920 BAYSWATER AVENUE
BURLINGAME, CALIFORNIA

ROOF PLAN HEIGHT EXHIBIT

3RD P.C. SUBMITTAL
06/07/2019

BAYSWATER
920 Bayswater Avenue
Burlingame, CA 94010

LEVEL 4 FLOOR PLAN PARTIAL 02
SCALE: 1" = 10'-0"

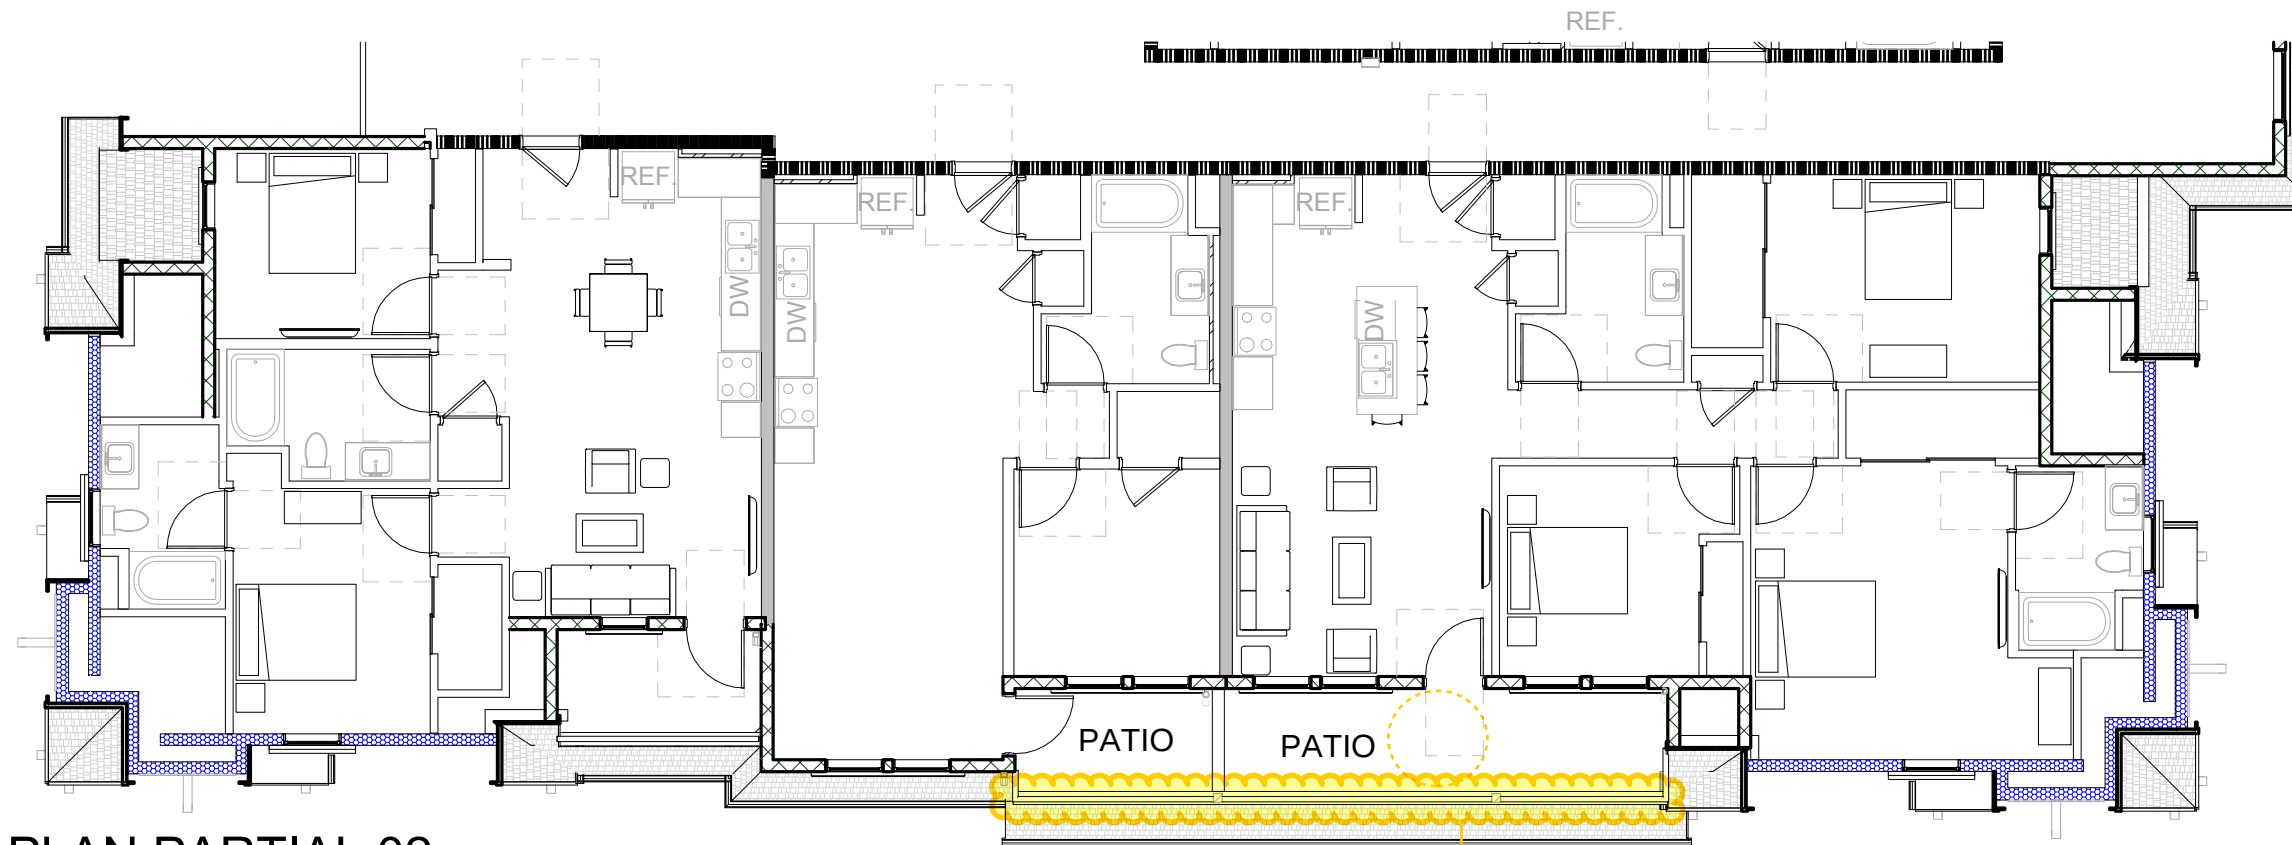
See response 2c

LEVEL 3 FLOOR PLAN PARTIAL 02
SCALE: 1" = 10'-0"

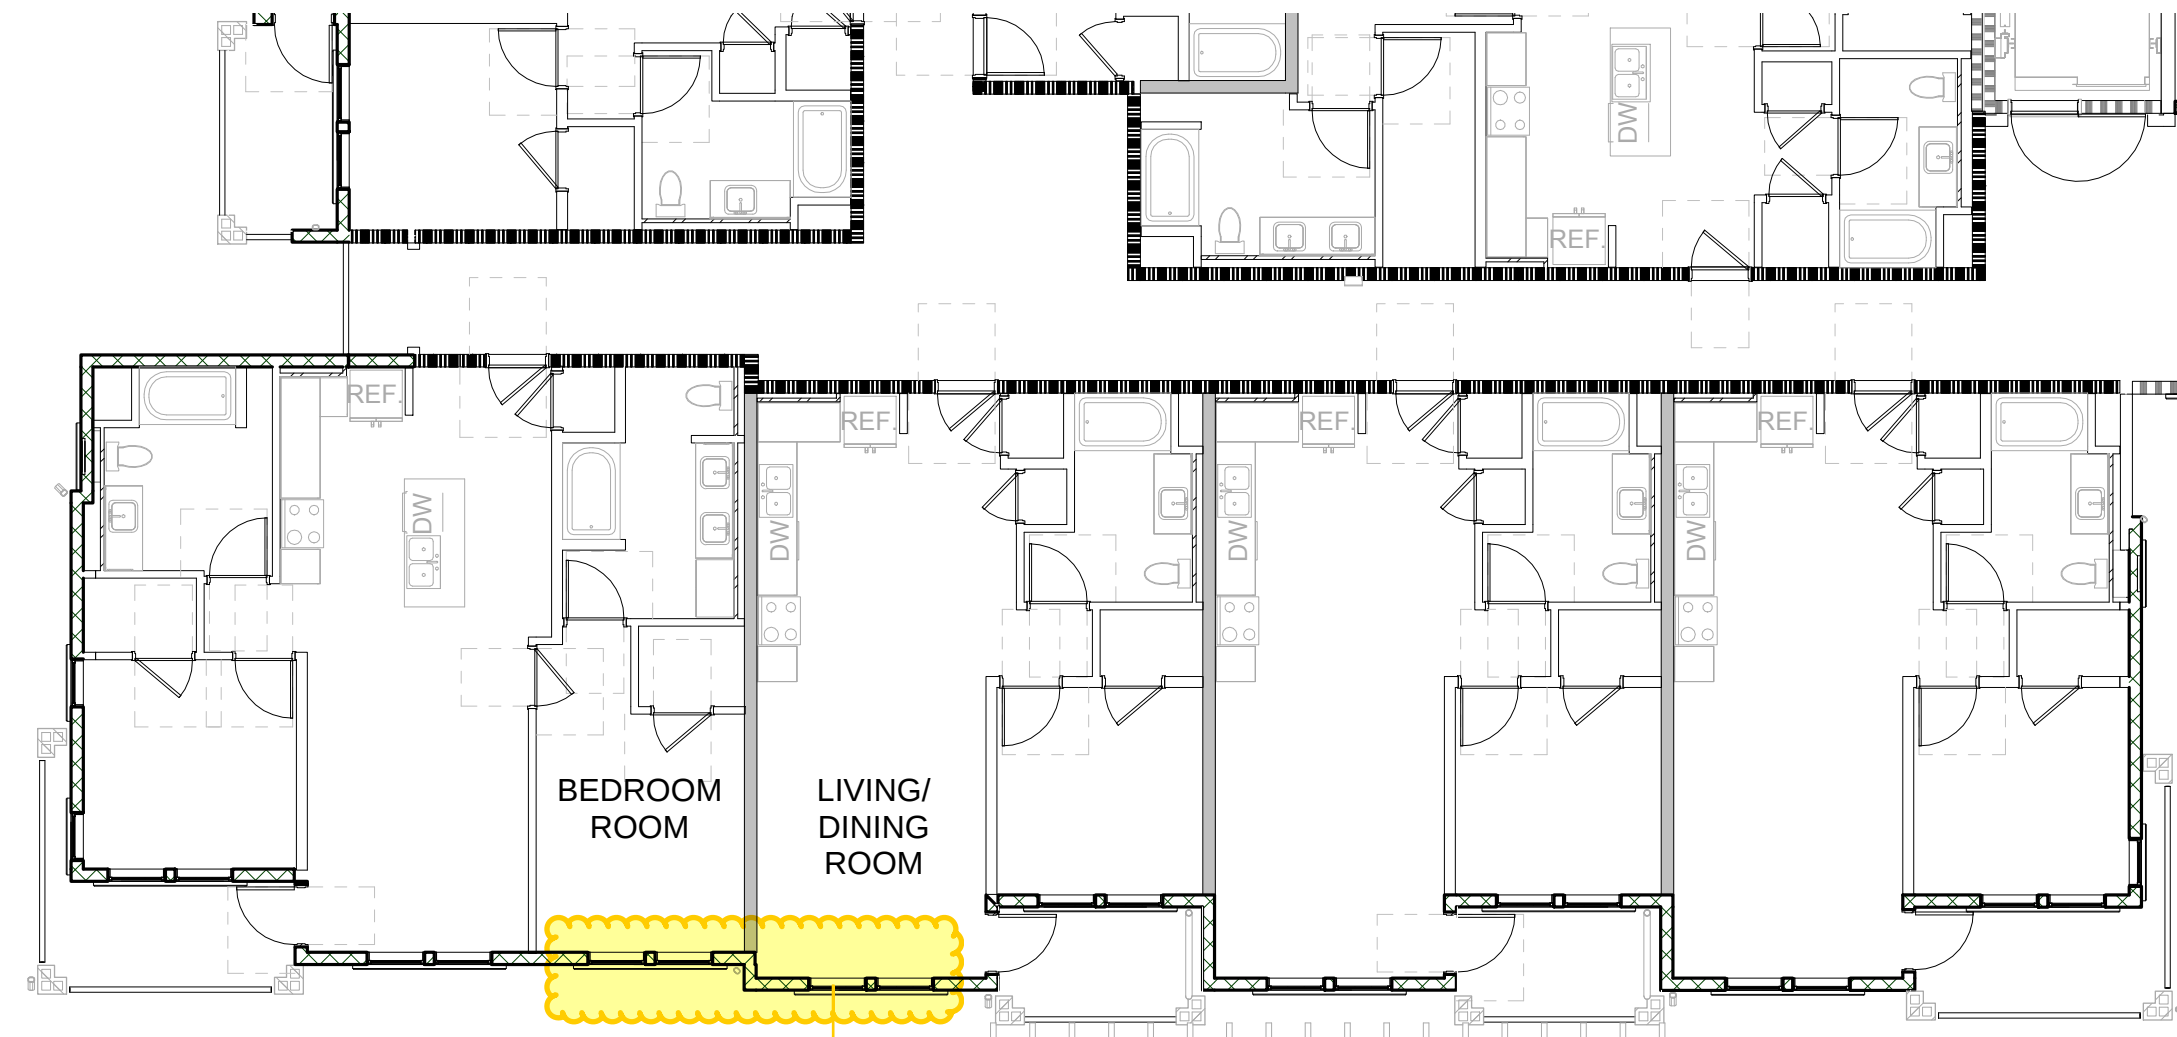
See response 2d
